Architectural Review and Historic Preservation Board Agenda Report

RE: Architectural Review 19-17 and Use Permit 19-12 (Elisha Court Apartments)
24 Elisha Court – APN 015-120-053

File: AR 19-17 UP 19-12

SITE PLAN

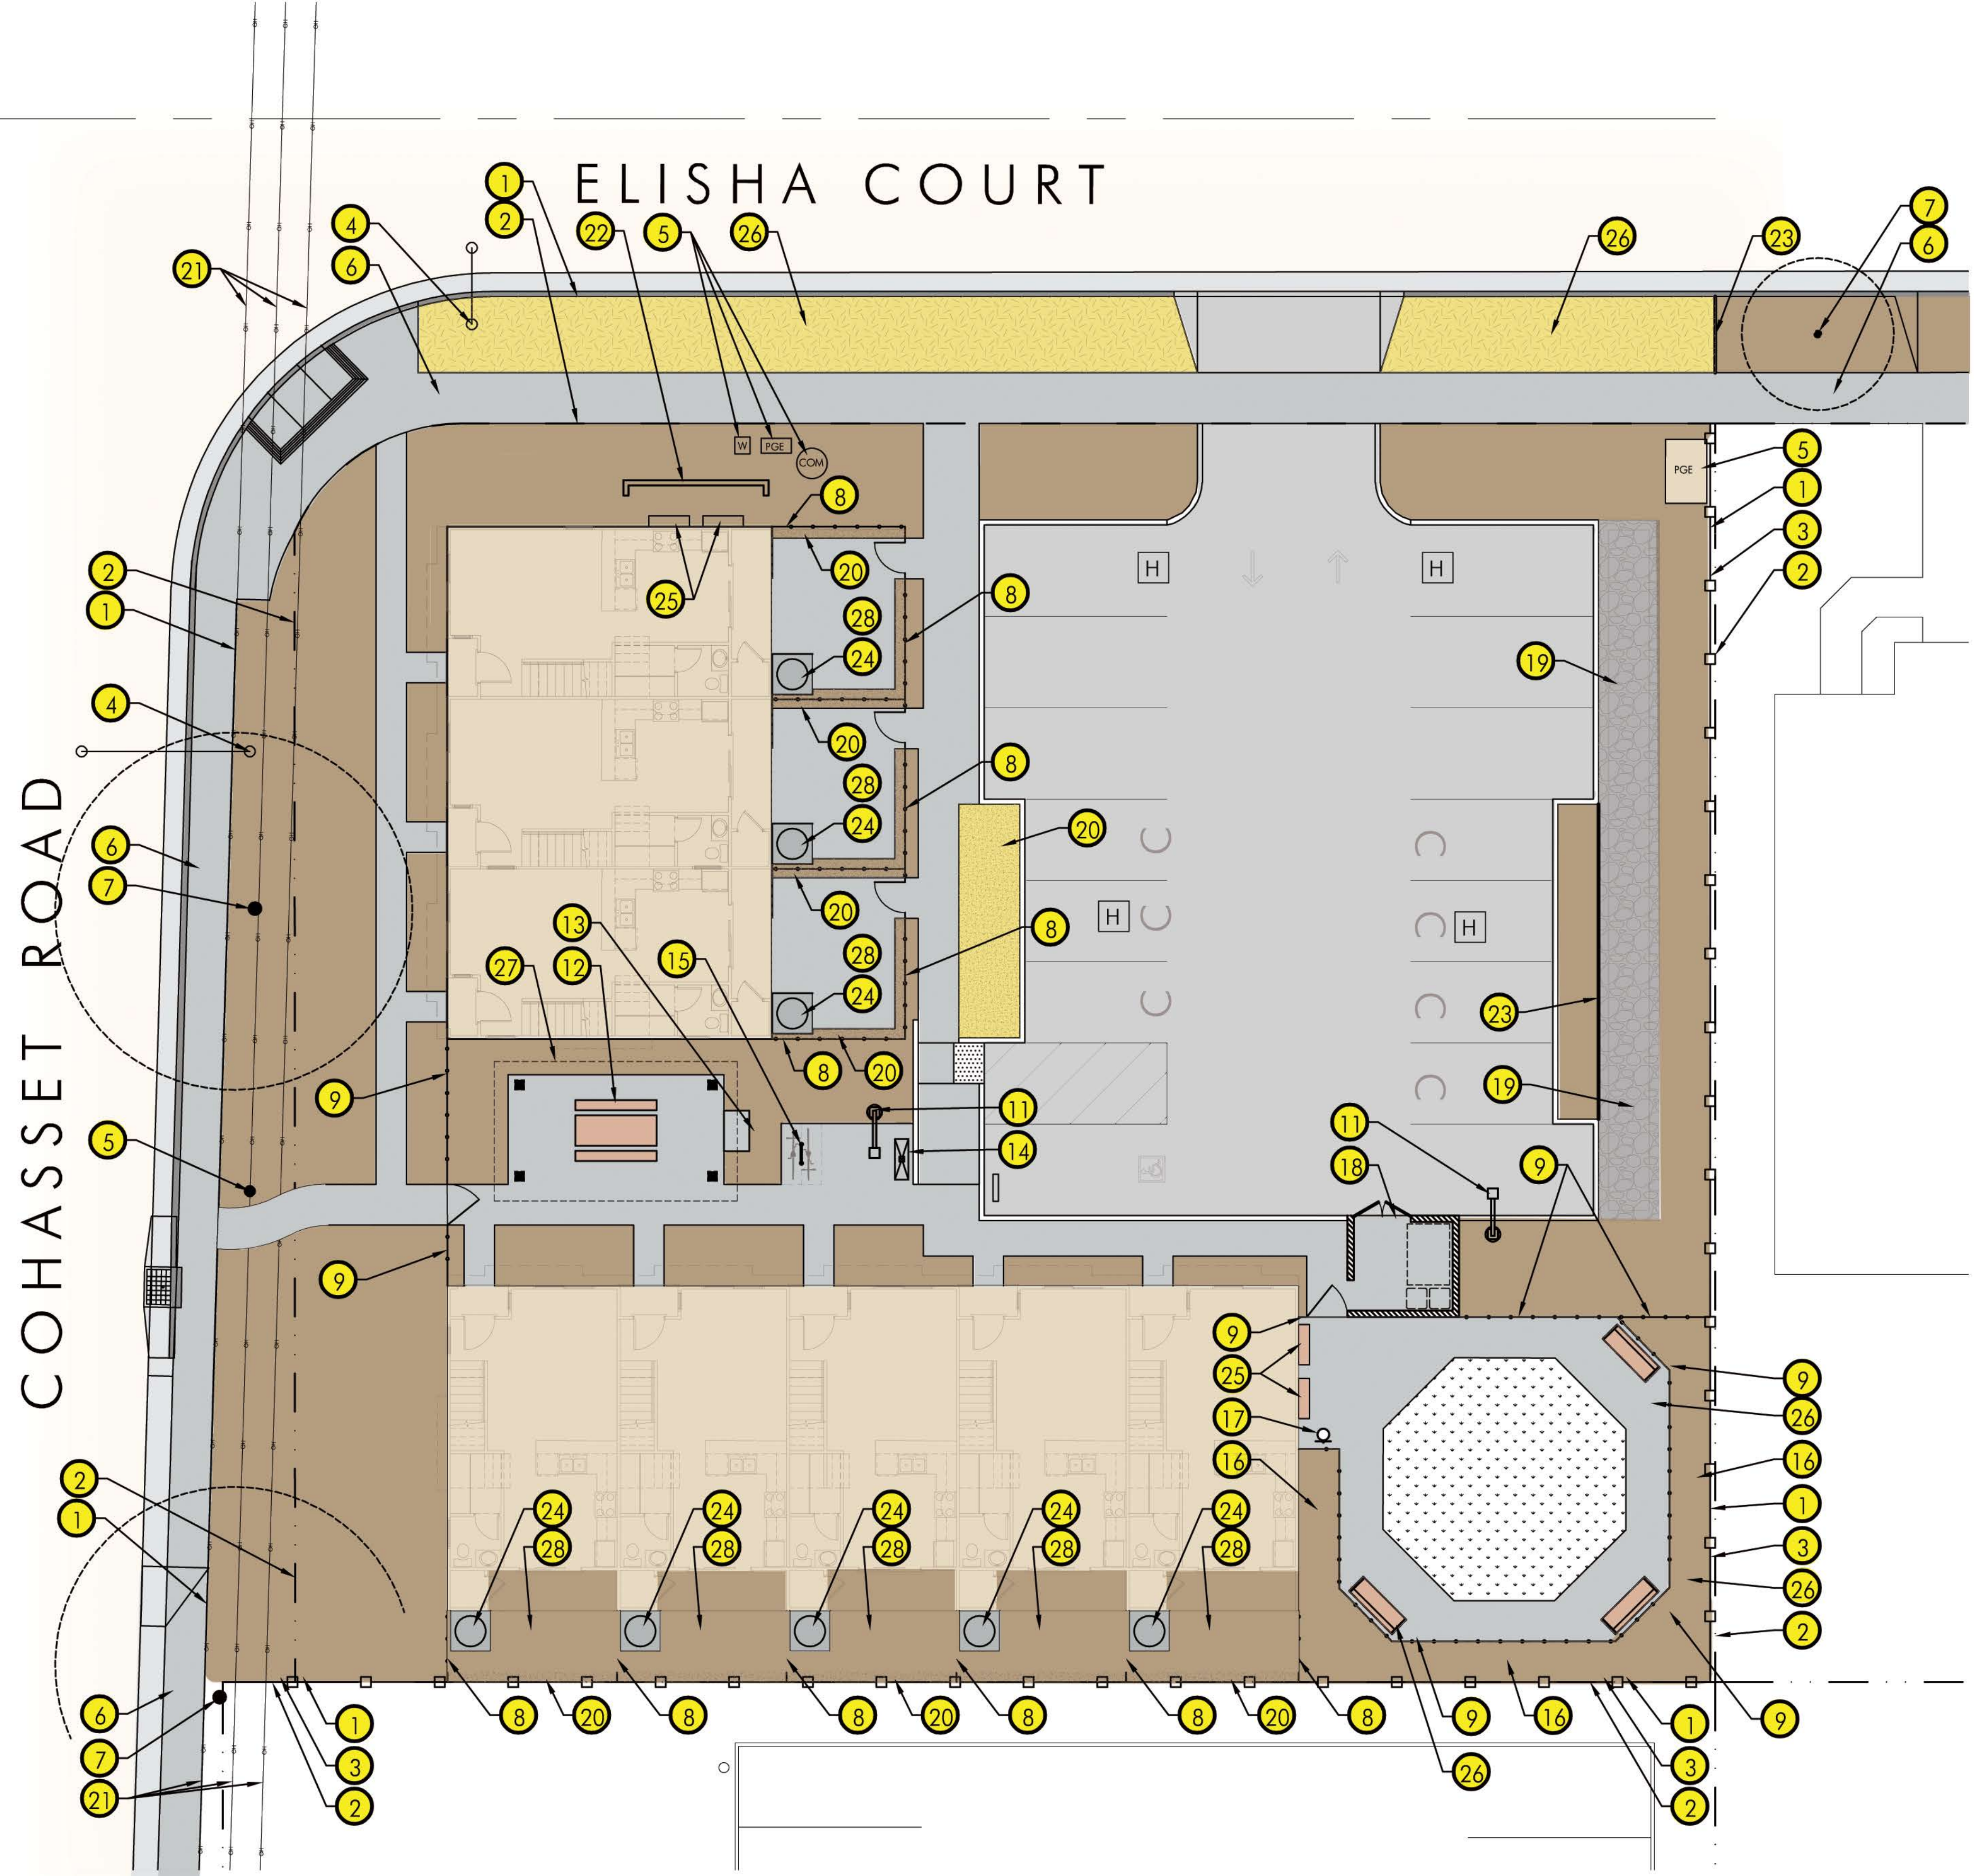
The site plan illustrates the layout and orientation of the buildings, as well as the location of the trash enclosure, site amenities and parking (see **Attachment B**, Floor Plan and Site Plan). The buildings are oriented primarily toward their parking area, though the north building does engage Cohasset Road.

The project includes a total of fifteen off-street parking spaces, adequate to the City's requirements. Required bicycle parking spaces would be provided primarily at the rear of each unit. The parking area and outdoor space would be properly lighted, and mechanical units would be appropriately screened in the private outdoor space of each individual unit. A trash enclosure, covered as required, is proposed adjacent to the parking area and the south building.

PRELIMINARY LANDSCAPE SITE PLAN

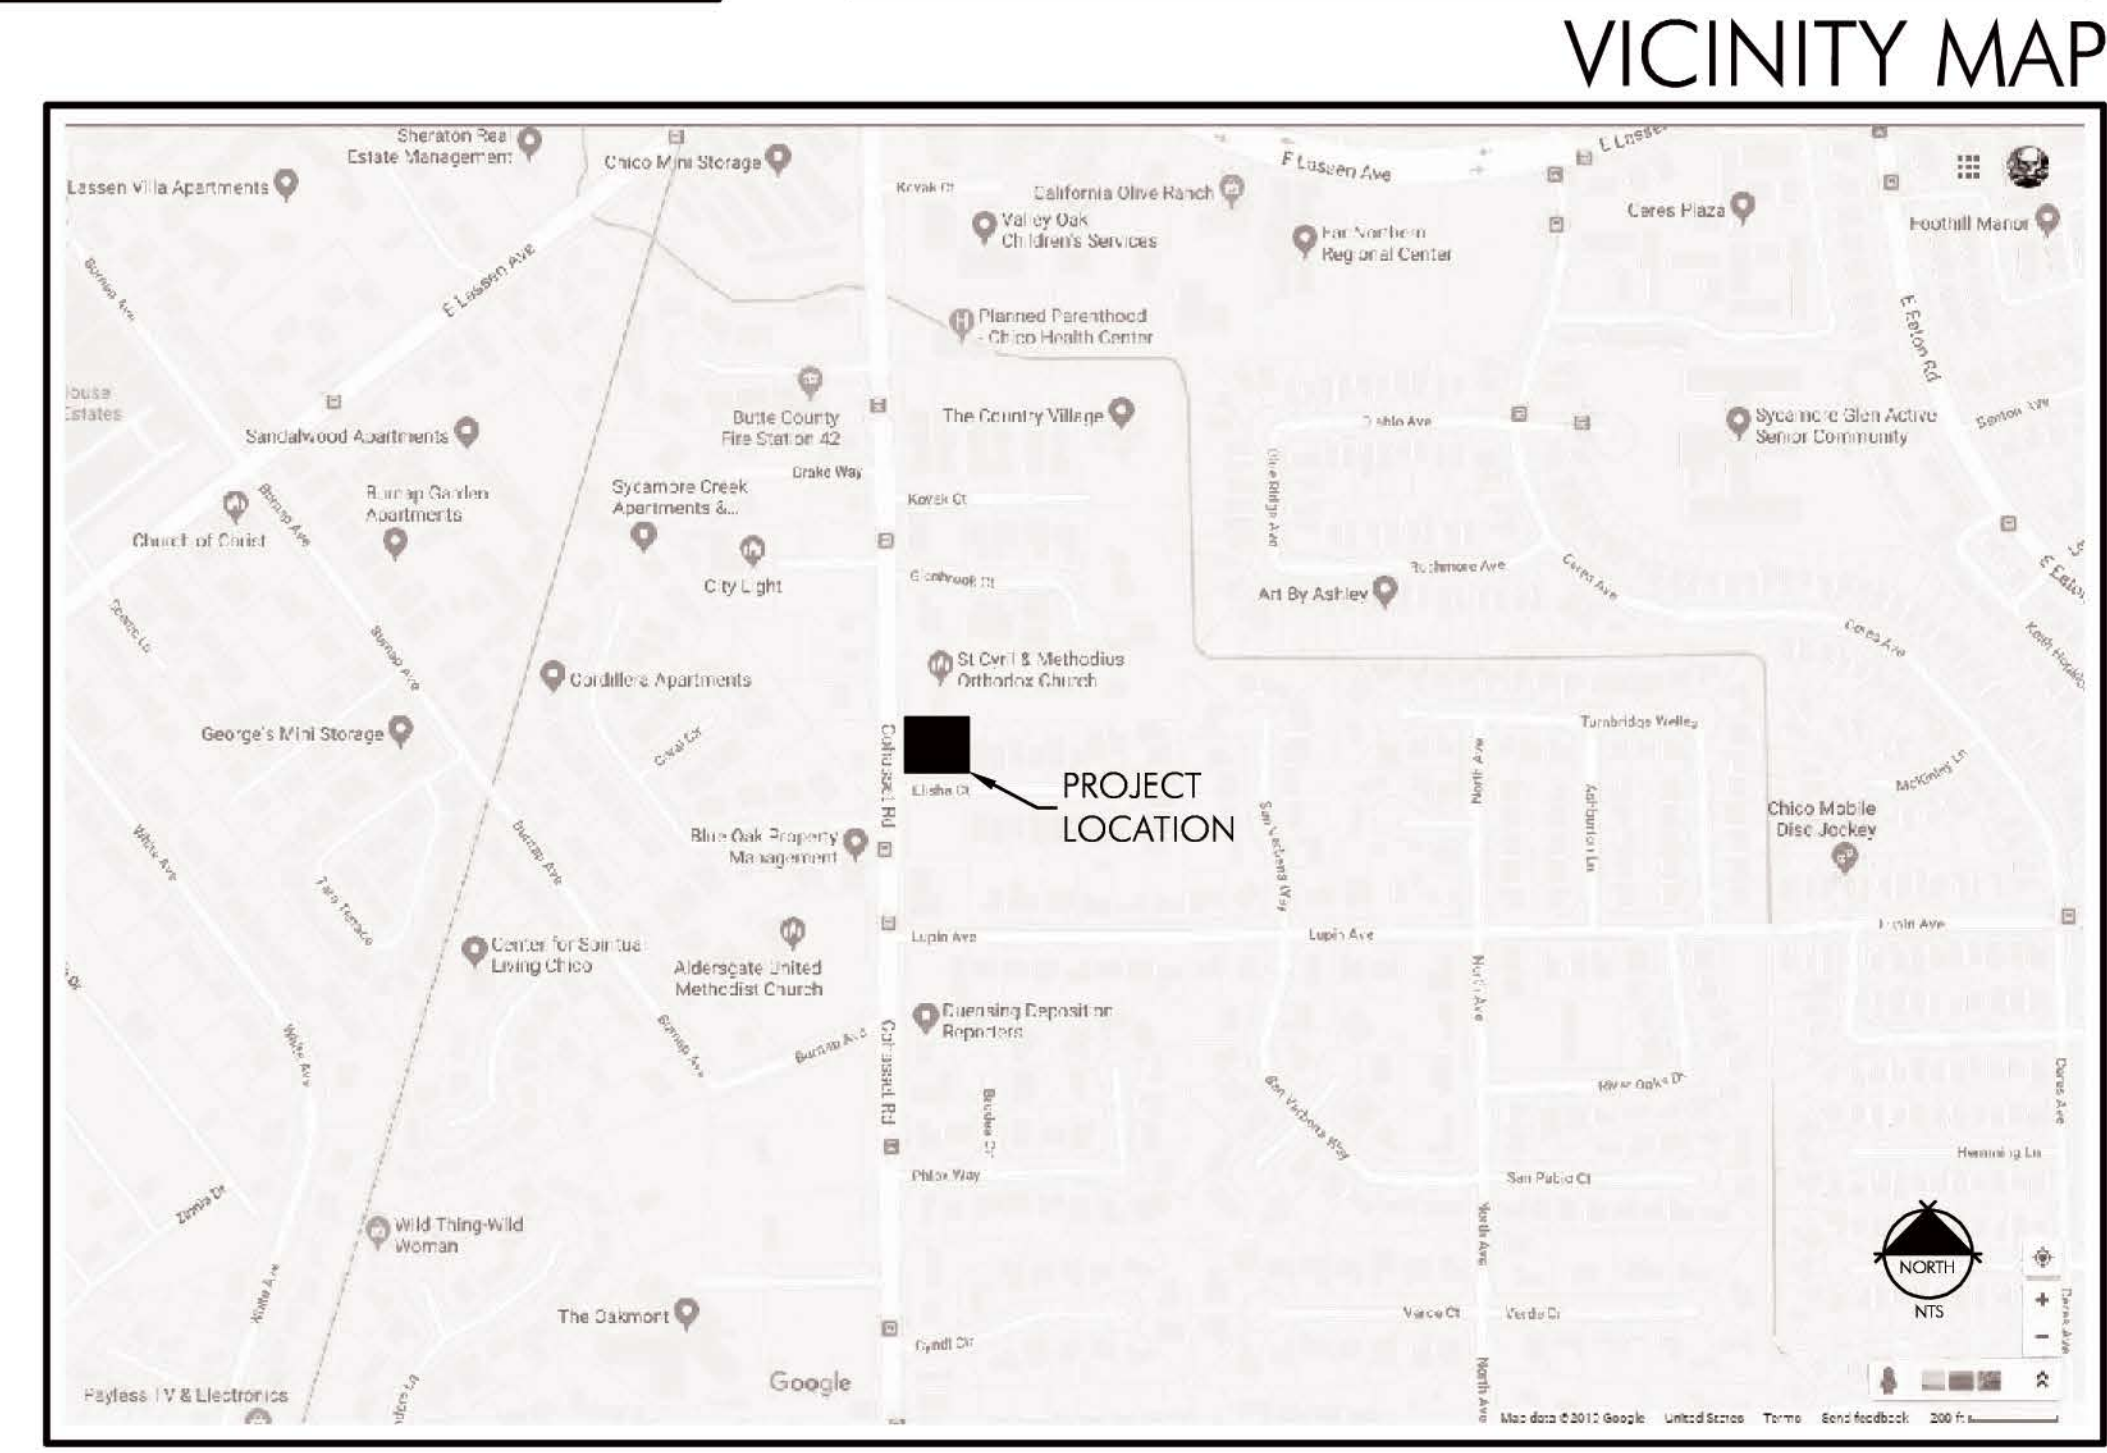
The landscape plans call for a variety of species with moderate water demands (see **Attachment C**, Landscape Plan). A mixture of trees, shrubs, and perennials is proposed in the limited landscape area. Parking lot shade is estimated to reach 50 percent at full tree maturity, and to be provided by two elms and two cedars. As of staff's site visit of August 19, 2020 there are a good number of trees on the edges of the site, and removal would be properly mitigated as shown in the landscape plans.

Landscape design includes a fair number of trees and bushes. The trees, shrubs, and other plantings are located throughout the development, but primarily around the parking area, which is the portion of the development most in need of visual relief. These choices compliment the proposed structure and enhance the visual environment of an already-attractive development. Parking lot shading is adequate, and the well-shaded and trellis-planted courtyard area will also contribute significantly towards providing an attractive residential environment.

ATTACHMENT ' G

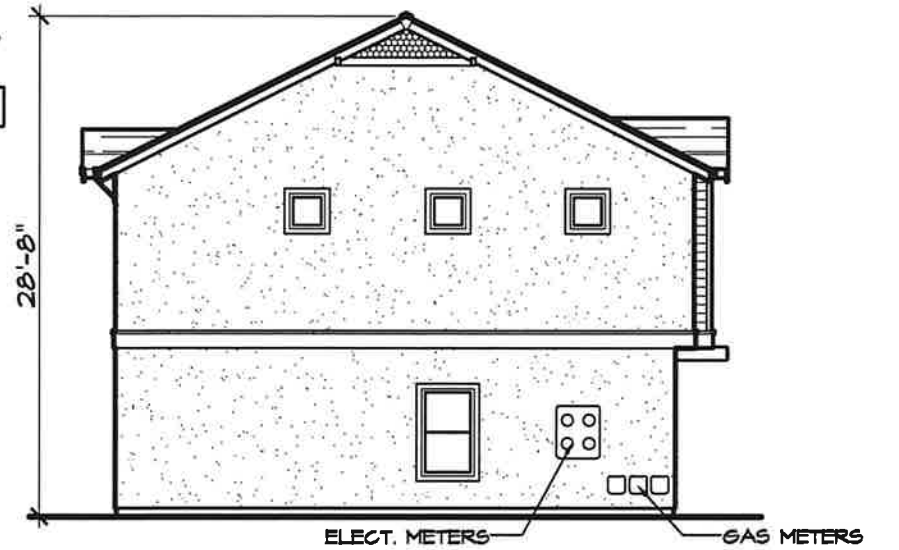
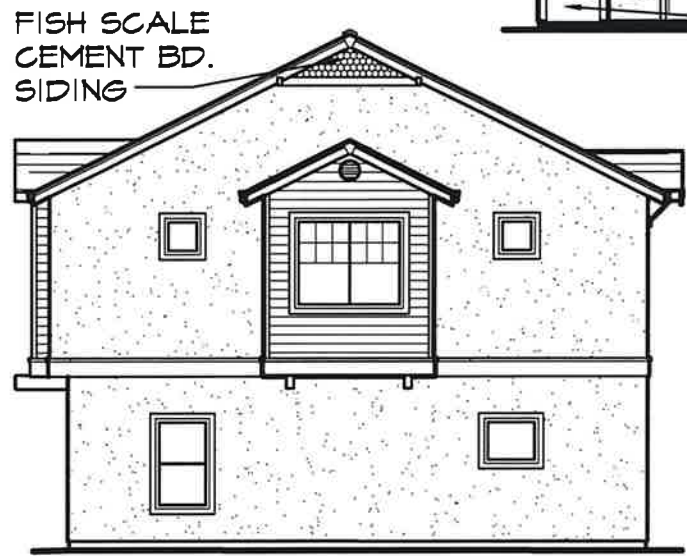
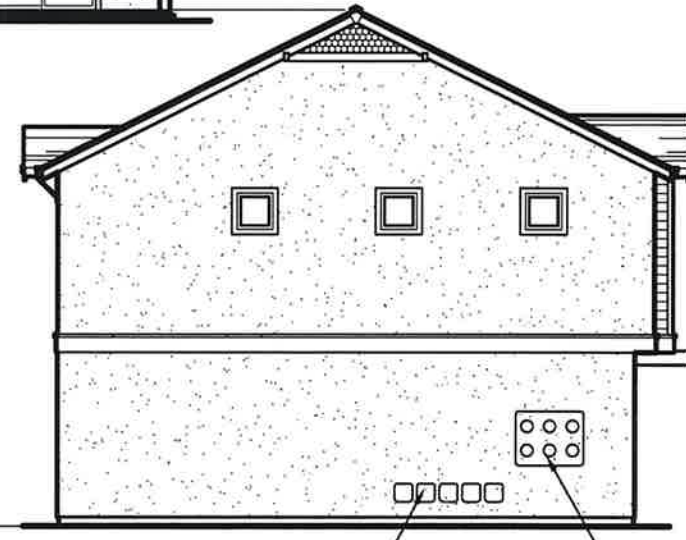
would be brown and window frames would be black vinyl. Roof material would be black composite shingles. All units would share the partially-covered and enclosed courtyard. Condition #5 would require decorative features like a mural to be added to the Cohasset Road and Elisha Court side elevations of the buildings in order to improve the street-facing aesthetic of the complex. Each unit would have its own enclosed outdoor space.

5. On the West elevation of the southern building and on the North elevation of the northern building, applicant shall install at applicant's expense a mural, other decorative works, or decorative plantings that in any case shall cover at least 50 percent of the area of the respective façade.
